# IEEE802.3da D3p2 review and comments

11/26/2025

Figure 189-9—Top level MPD state diagram continued, part b

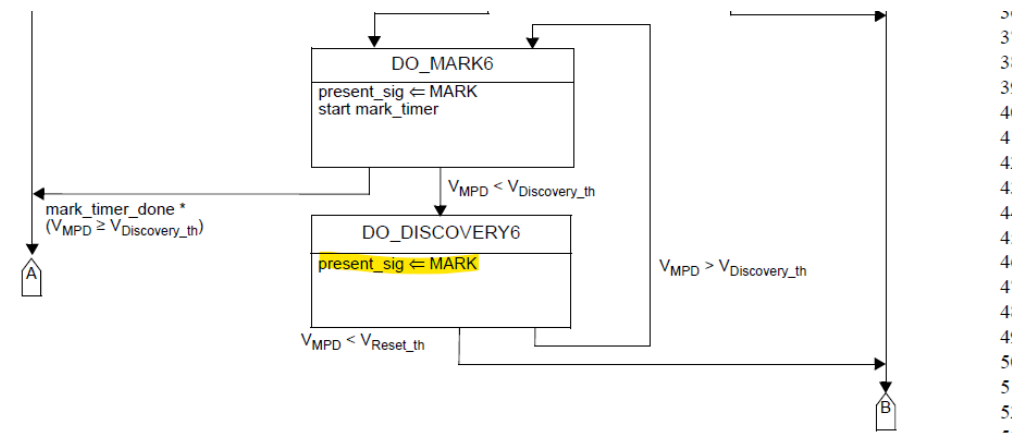
Clause/Table	Issue	Suggested remedy	Notes
Table 189-8	<ol style="list-style-type: none"><li>In discovery event 6 there are x for type 0, type 1, type 0/1 .According to flow chart it should be 0, see next page</li><li>No definition of extended discovery</li></ol>	<ol style="list-style-type: none"><li>In Discovery Event 6 event change x to 0</li><li>Make separate note or add to the table text: Extended discovery is for future extension</li></ol>

- On flow chart value at event 6 is 0 (present MARK)

Insert extra bit at DISCOVERYx EVENT 6 for future extension

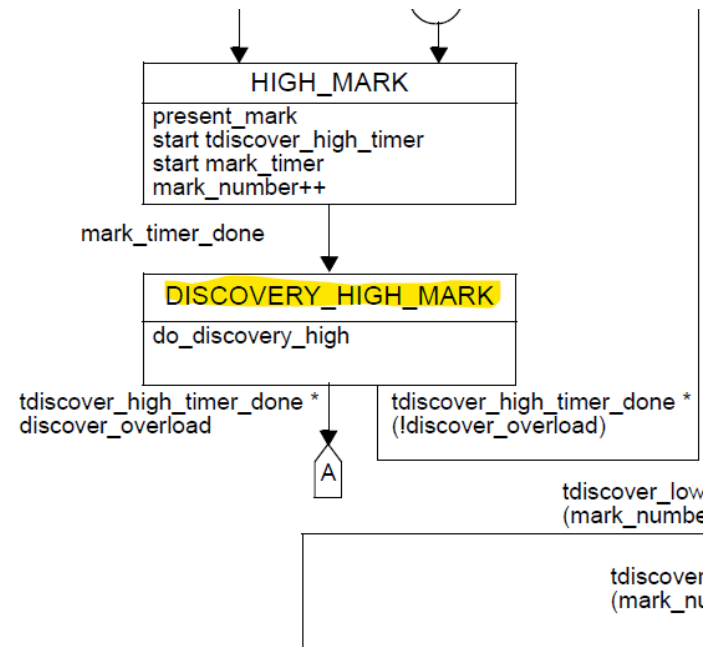
Clause/Table	Issue	Suggested remedy	Notes
Paragraph 189.4.4.3 Functions	1. In flow chart we have state DISCOVEY_HIGH_MARK but in definitions do_discovery_high or do_discovery low we call this state DISCOVEY_HIGH – no word <b>MARK</b>	1. Change in functions do_discovery_high and do_discovery low state function name from DISCOVERY_HIGH to DISCOVERY_HIGH_ <b>MARK</b> , see next page

Values: TRUE: Measured IDiscovery was equal to or greater than IDiscovery\_LIM during most recent DISCOVERY\_HIGH\_MARK or DISCOVERY\_LOW state.

FALSE: Measured IDiscovery was less than IDiscovery\_LIM during most recent DISCOVERY\_HIGH\_MARK or DISCOVERY\_LOW state.
